LOUDOUN COUNTY
DEPARTMENT OF PLANNING

Graham House, 40171 Main Street, Waterford, Loudoun County,

DHR File No. 401-0013 ep

Application for Approval of Exterior changes

Current photo of the front elevation showing the iron understructure of the removed balcony and the posts on the house where it was attached.

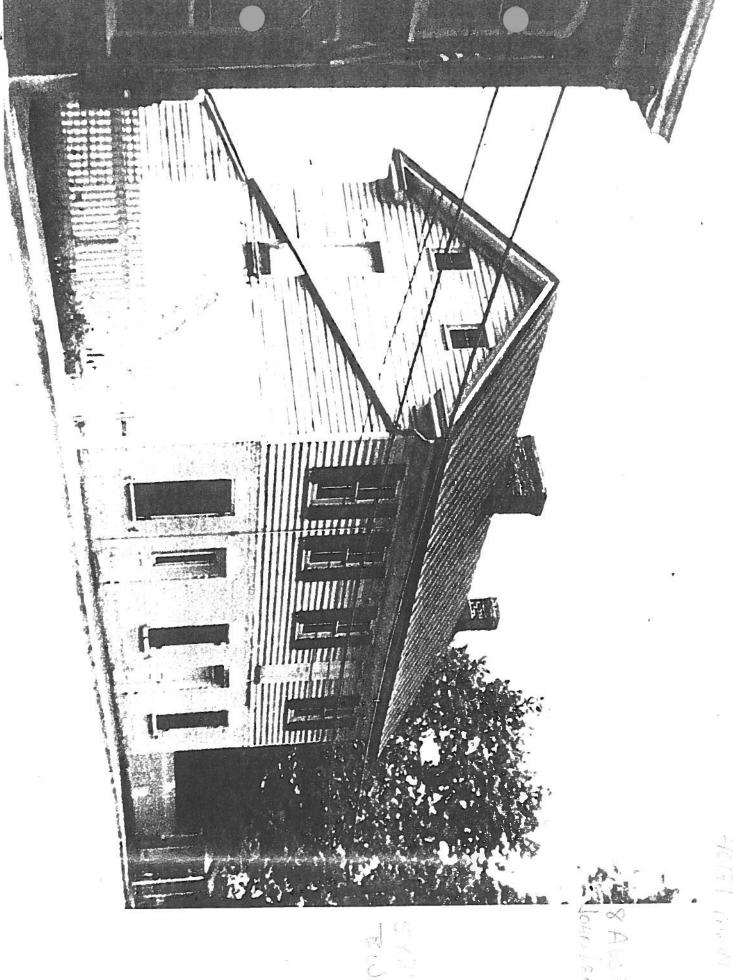
We have reviewed your request for a replacement wooden rail on the second story door. This rail will be a two-part rail between the door jambs and address clear safety concerns. In appearance, it will be of the same style and proportions as the existing rail on the south elevation of the building. After careful review, the proposed work is in keeping with the provisions of the easement and complies with the Secretary of the Interior's Standards for Rehabilitation and is, therefore, approved.

We would like to propose a wooden rail on the door with the same style and proportions as the second story door on the south (right side) elevation and the rear porch rail. This rail would not be part of a balcony, but simply be a 2-part rail between the jambs of the door to prevent falls, while still allowing the door to be opened for ventilation. This style is seen on the photos below.
